Attachment 2

Mark-ups for the Associated COLA Revisions for 2.5.2 RAIs

2.5.2 Roadmap

Mark-up for FPL Revised Response
to NRC RAI No. 02.05.02-2 (eRAI 5896)

Figure 2.5.2-258a

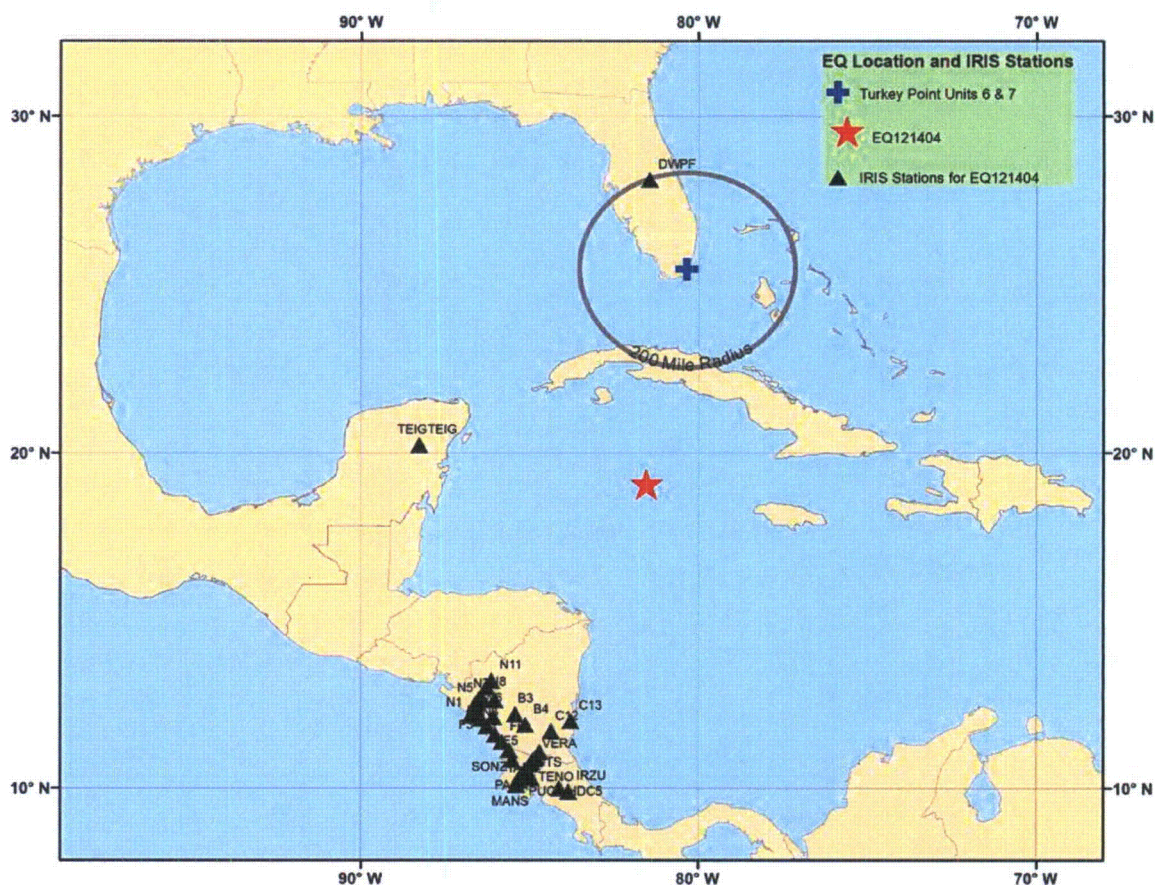
This event occurred in the Caribbean Sea region and its epicenter is shown in Figure 2.5.2-258a along with the Turkey Point Units 6 & 7 site location, and the location of the IRIS stations that recorded this earthquake and were analyzed. Based on the observed station distribution, the IRIS station DWPF located in central Florida has the most applicable source to site path for this comparison. The GMPE curves and empirical data are shown in Figures 2.5.2-258b and 2.5.2-258c for the 1 Hz and 2.5 Hz spectral frequencies. The data point from the DWPF station is highlighted as a solid blue symbol. Overall the empirical data both as recorded and with the site condition correct factors applied falls below the median Caribbean GMPE curve (heavy red line) and has values which that are in the lower distribution range of Caribbean GMPE curves.

Figure 2.5.2-259a

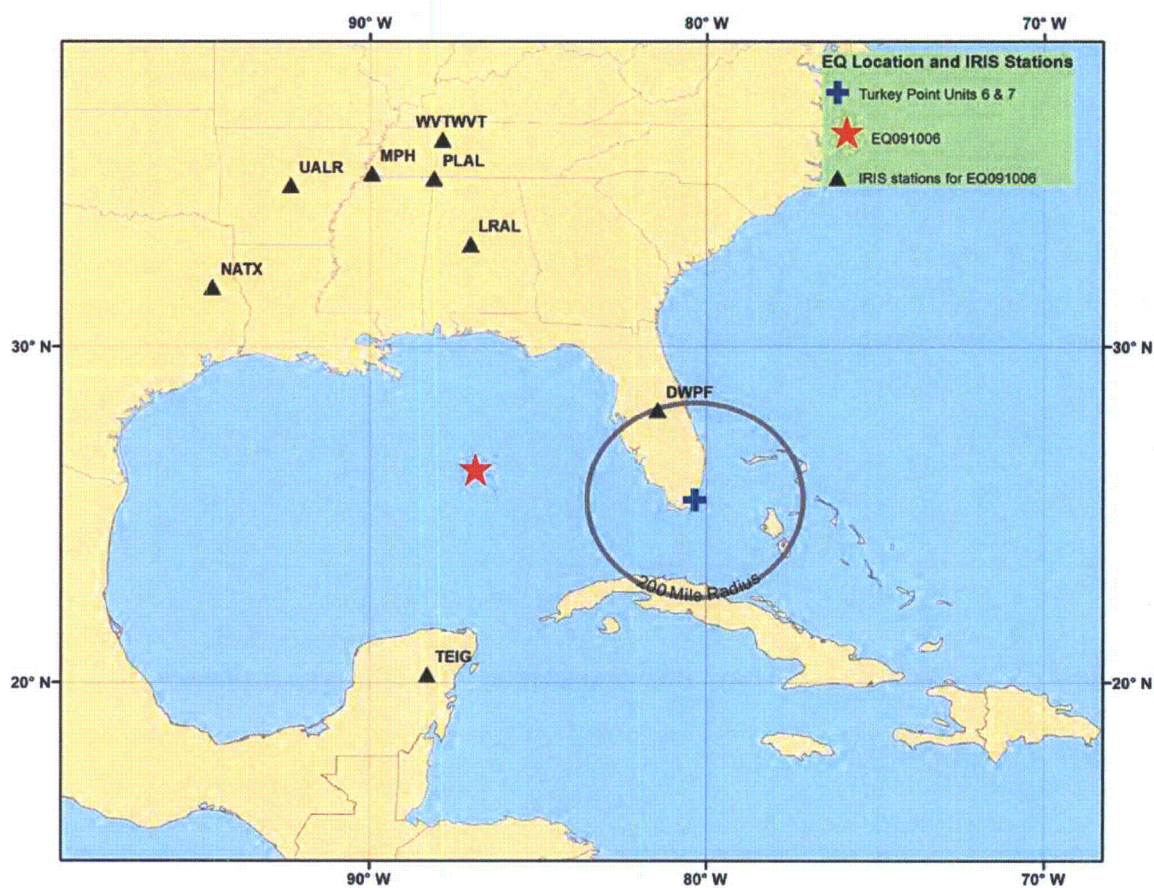
This event occurred in the Gulf of Mexico and its epicenter is shown in Figure 2.5.2-259a along with the Turkey Point Units 6 & 7 site location, and the location of the IRIS stations that recorded this earthquake and were analyzed. Based on the observed station distribution, the IRIS station DWPF located in central Florida has the most applicable source to site path for this comparison. Out of the five earthquakes considered in this analysis, this event has the most consistent tectonic structure between the earthquake and the Turkey Point Units 6 & 7 site and can be considered as the best representative event for events occurring in and around the island of Cuba and being observed in S southern Florida. The distribution of stations in the central United States have has a less applicable travel path azimuth and may show different attenuation properties based on these different tectonic travel paths. The GMPE curves and empirical data are shown in Figures 2.5.2-259b and 2.5.2-259c for the 1 Hz and 2.5 Hz spectral frequencies.

Figure 2.5.2-259b

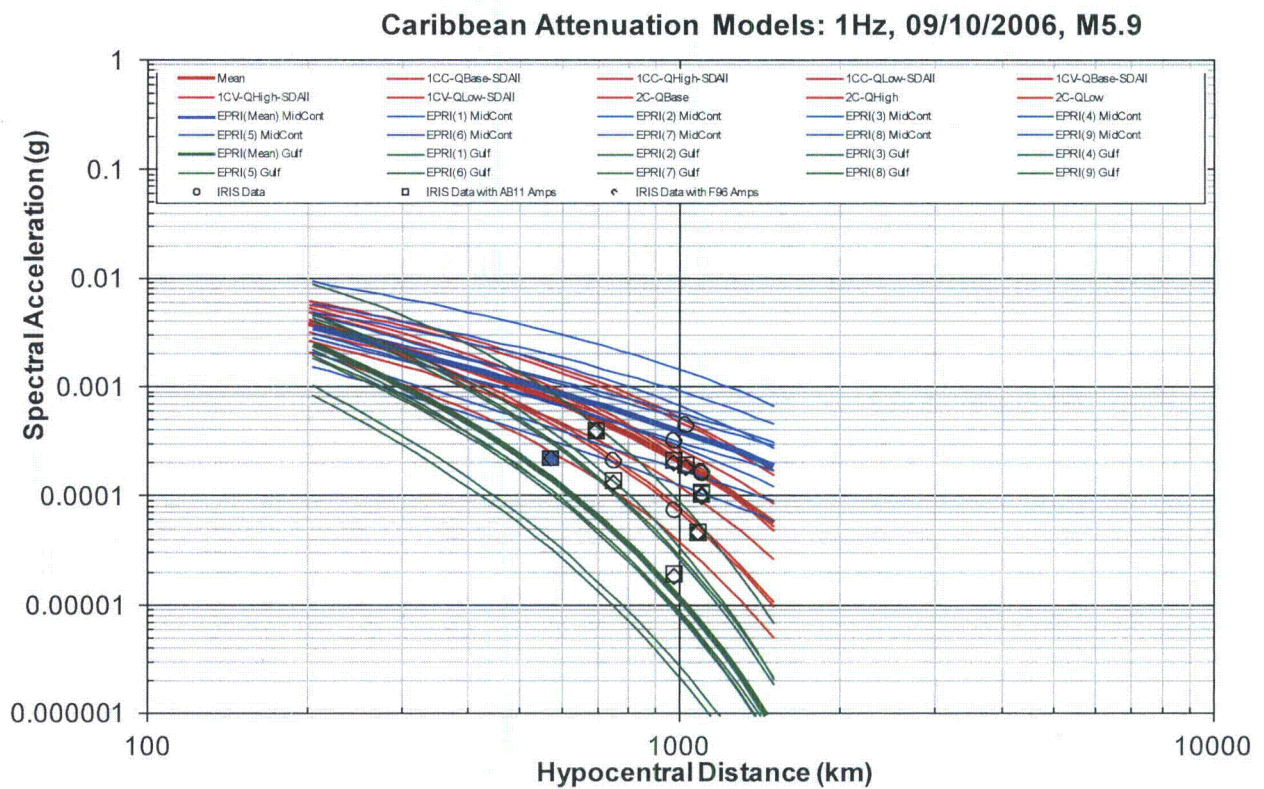
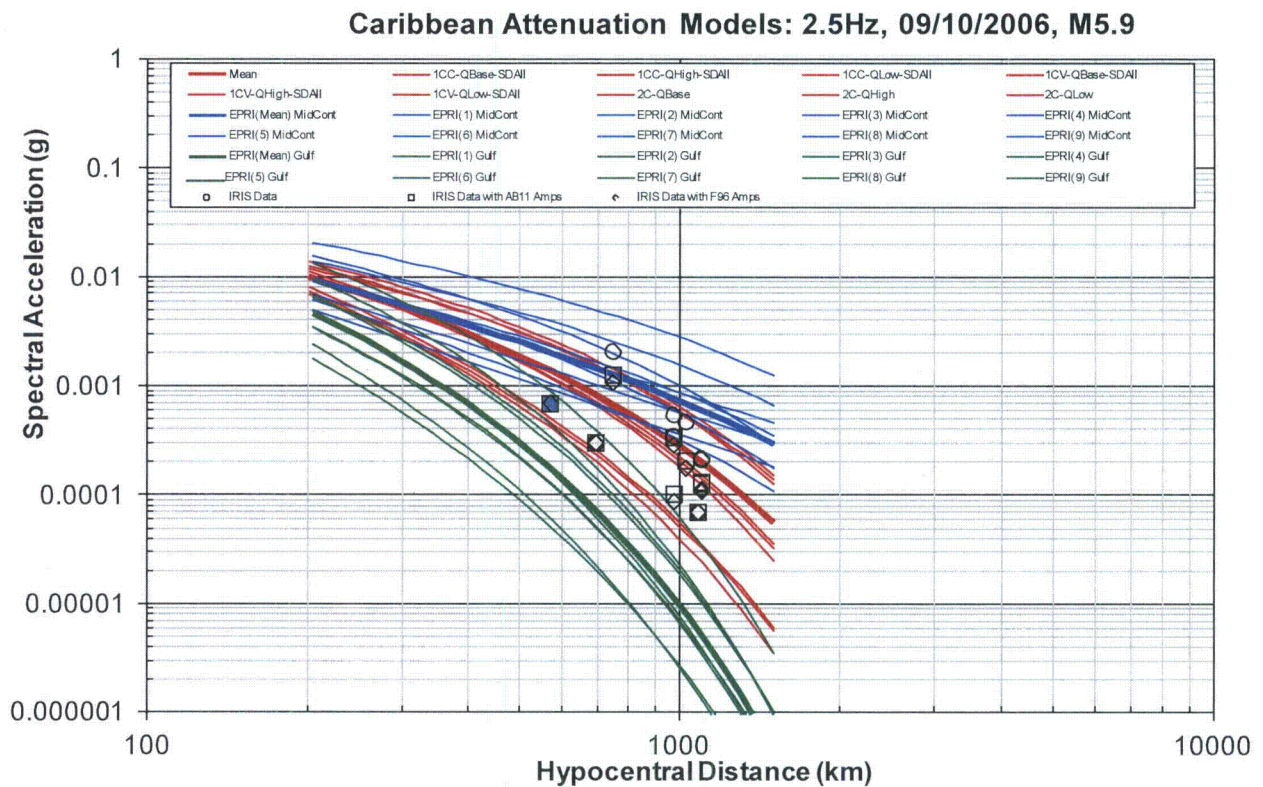
The data point from the DWPF station is highlighted as a solid blue symbol. In general the empirical observations fall within the range of the Caribbean GMPE curves with the single exception of station LRAL (i.e., at a distance of ~~about~~ **approximately 750 km kilometers [466 miles]**) for 2.5 Hz in which the unadjusted empirical data exceeds the highest Caribbean GMPE curve. For this station and frequency, however, the CEUS hard rock adjusted ground motions fall within the range of Caribbean GMPE models which are defined for CEUS hard rock site conditions. It can also be concluded from the comparison plots in Figures 2.5.2-259b and 2.5.2-259c, that the distribution of the current Caribbean GMPE curves adequately captures the range of the empirical data. In addition, the observation from the DWPF station is in the lower range of the Caribbean GMPE curves.

Figure 2.5.2-260a

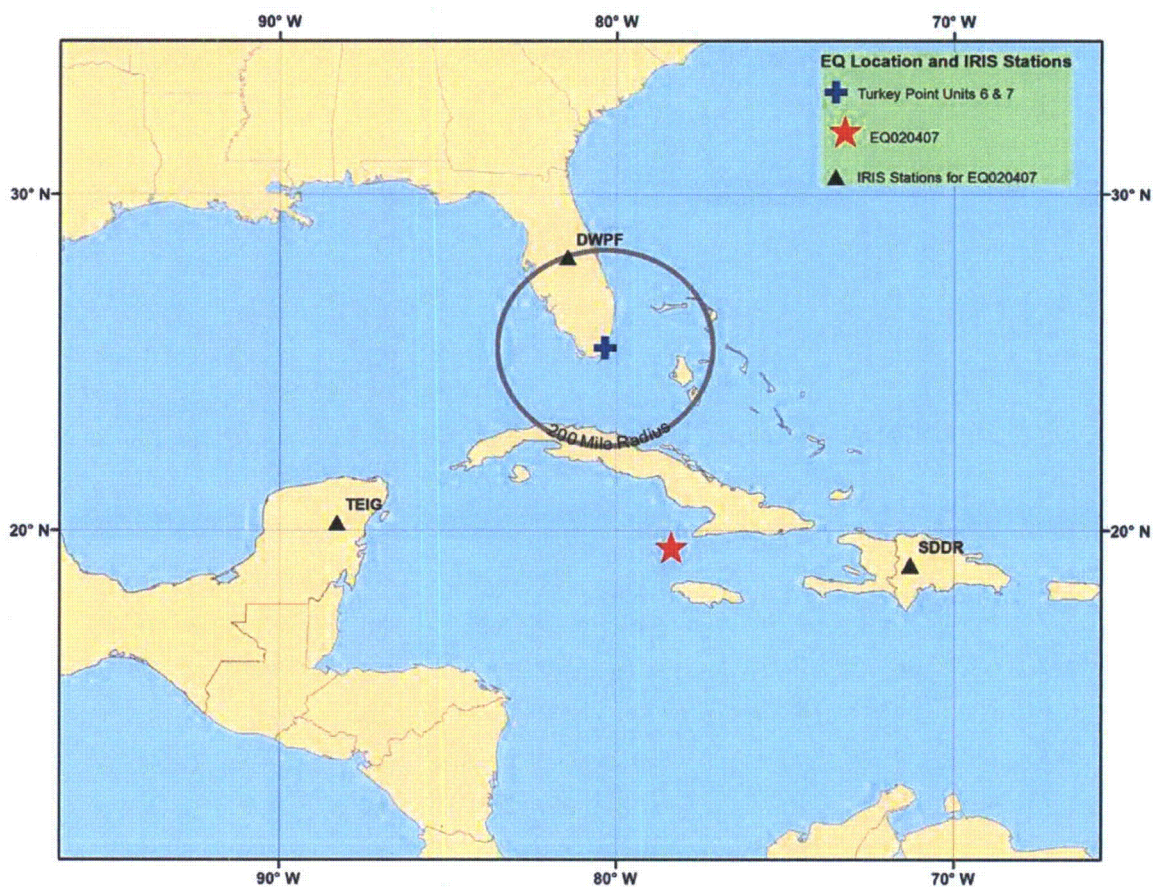
This event occurred south of the island of Cuba and its epicenter is shown in Figure 2.5.2-260a along with the Turkey Point Units 6 & 7 site location, and the location of the IRIS stations that recorded this earthquake ~~and~~ **were analyzed**. Only three IRIS stations were analyzed from this earthquake and their station locations are shown in Figure 2.5.2-260a. Based on the observed station distribution, the IRIS station DWPF located in central Florida has the most applicable source to site path for this comparison. The GMPE curves and empirical data are shown in Figures 2.5.2-260b and 2.5.2-260c for the 1 Hz and 2.5 Hz spectral frequencies. The data point from the DWPF station is highlighted as a solid blue symbol. Overall the empirical data falls below the median Caribbean GMPE curve (heavy red line) and has values ~~which that~~ **are** in the lower distribution range of Caribbean GMPE curves. In addition, the observation from the DWPF station is similar to the lowest Caribbean GMPE curve or lower.

Figure 2.5.2-261a

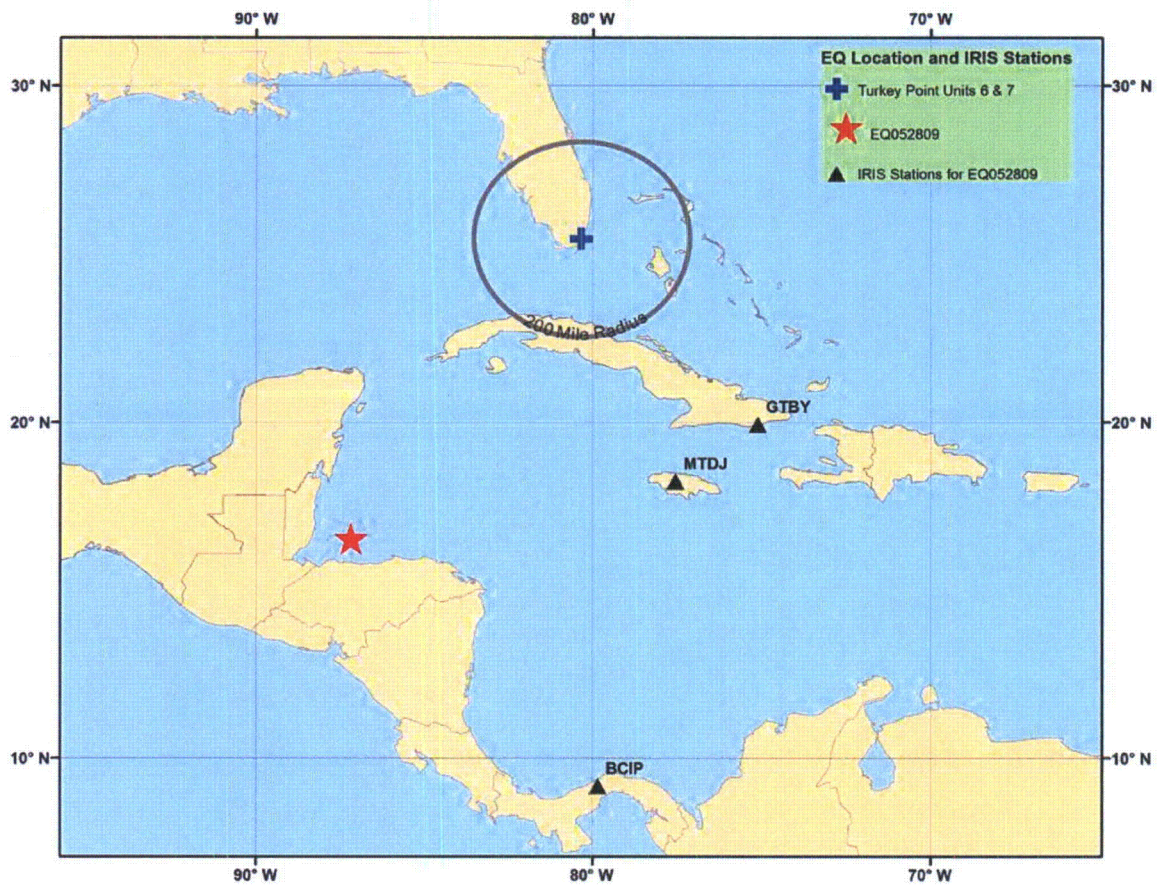
This event occurred north of Honduras in Central America and is the largest earthquake in the suite of five events analyzed in this sensitivity study. The location of its epicenter is shown in Figure 2.5.2-261a along with the Turkey Point Units 6 & 7 site location, and the location of the three IRIS stations that were analyzed. Based on the azimuths from the earthquake to the three IRIS stations, none of the associated seismic ray travel paths are ideal for this comparison study. The **GMPE attenuation** curves and empirical data are shown in Figures 2.5.2-261b and 2.5.2-261c for the 1 and 2.5 Hz spectral frequencies. The comparisons provided in the figures indicate that the empirical data from this earthquake are lower than any of the Caribbean **GMPE attenuation** curves.

Figure 2.5.2-262a

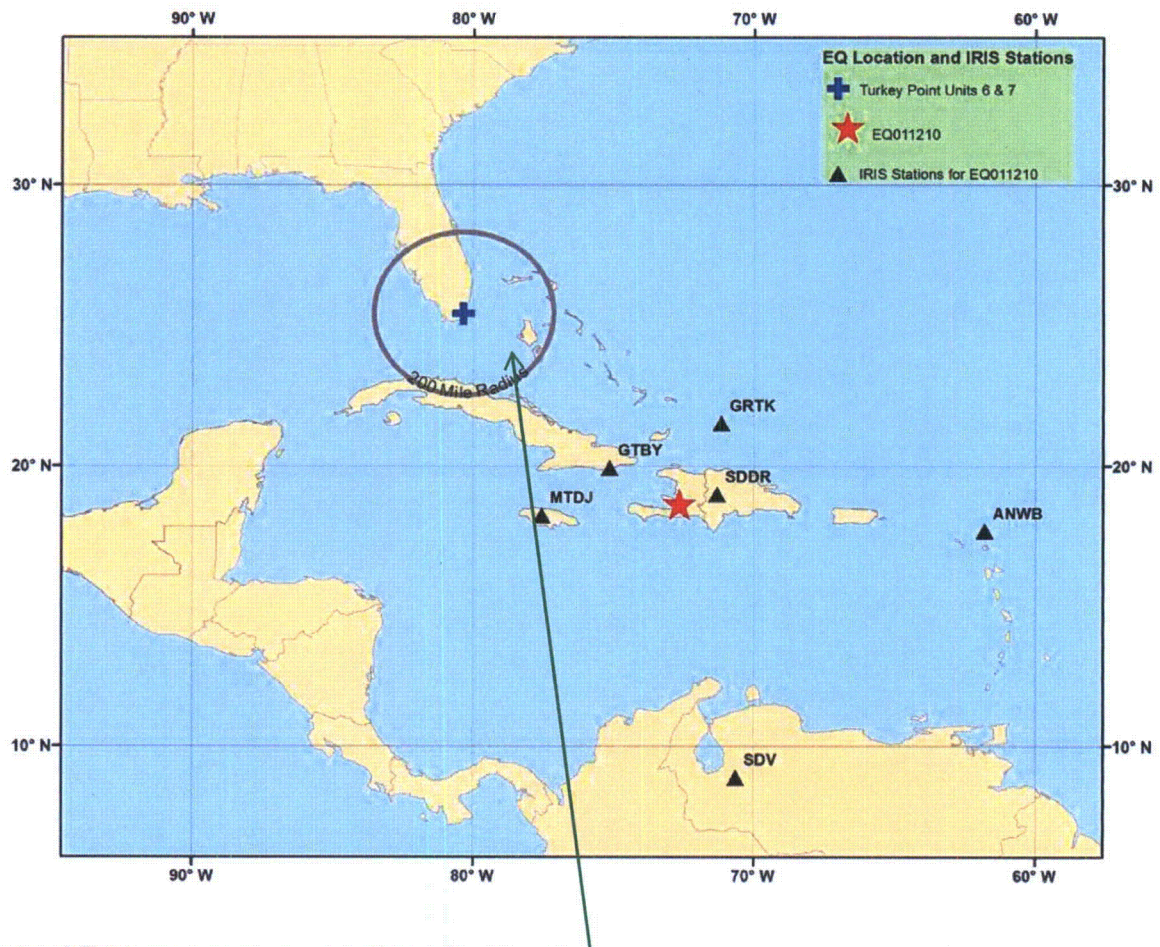
The Haiti earthquake is the most recent event in this suite of five earthquakes analyzed. The epicentral location and the suite of IRIS stations analyzed are shown in Figure 2.5.2-262a. Note that the data from the DWPF was not available for this earthquake. For the SDV station, only one single horizontal component was available and thus was not included in the comparison which was based on the geometric mean of two horizontal component ground motions. The large distance and undesirable azimuthal direction away from **Southern southern** Florida for this station from this earthquake provides an additional justification for not including this station in the comparison. The GMPE curves and empirical data are shown in Figures 2.5.2-262b and 2.5.2-262c for the 1 Hz and 2.5 Hz spectral frequencies. The data point from the OTAV station is highlighted as a solid blue circle. Overall the empirical data falls in the lower range or lower than the **Caribbean GMPE** attenuation curves. In addition, the observation from the OTAV station is significantly lower than the entire range of the Caribbean GMPE curves.

Iris Station OTAV was not removed in COLA Revision 5

Figure 2.5.2-263

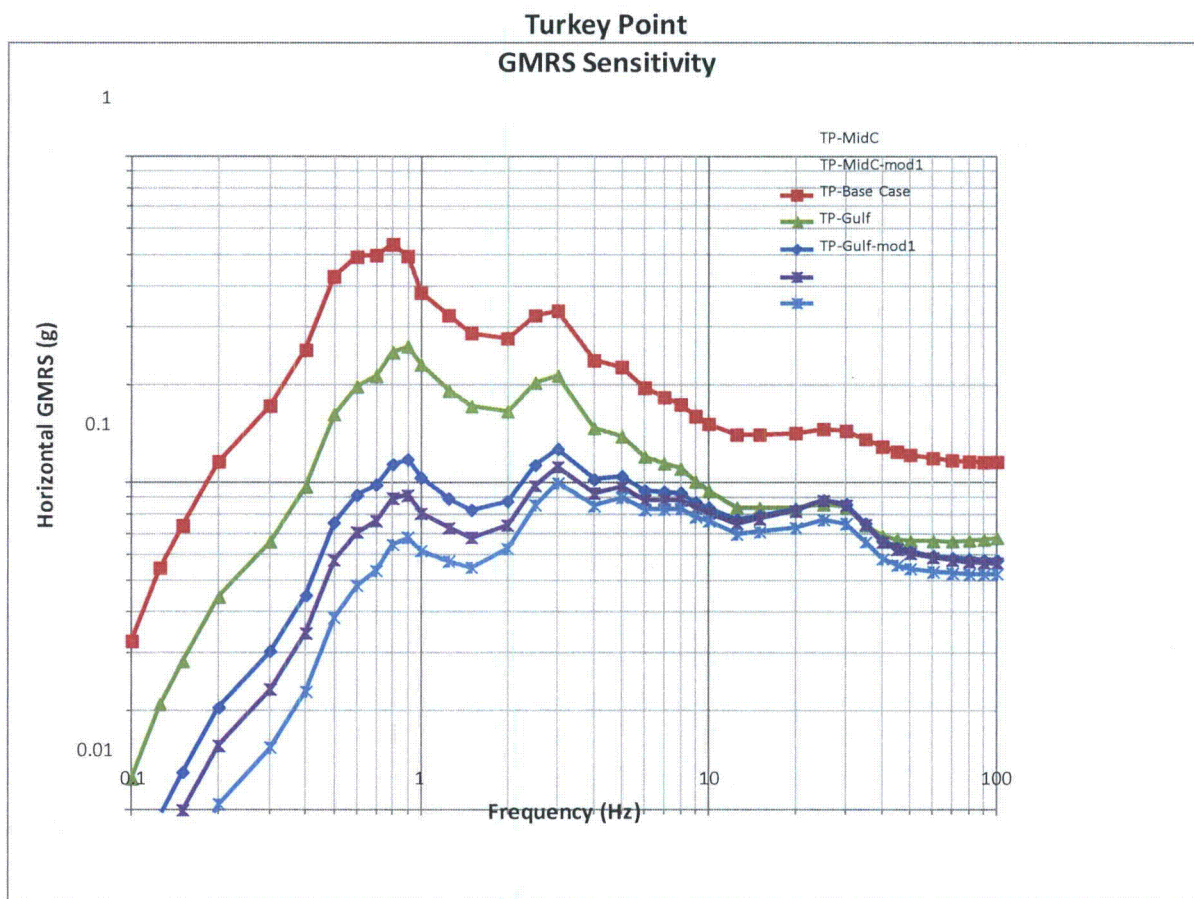
horizontal GMRS are plotted in Figure 2.5.2-263 and are developed using the site amplification factors. In general, the GMRS results using the EPRI Gulf Coast GMPEs are equal to or lower than the results using the Caribbean GMPE (i.e., indicated as Base Case in Figure 2.5.2-263). For the EPRI Mid-continent GMPE, the opposite result is concluded in which the GMRS values exceed the GMRS values using the Caribbean GMPE models, however, based on the previous additional sensitivity, the EPRI Mid-continent models predicts higher ground motions than the empirical ground motions and as such may not be applicable for the modeling of ground motion attenuation for seismic sources in this Caribbean region and the Turkey Point Units 6 & 7 site location in southern Florida.
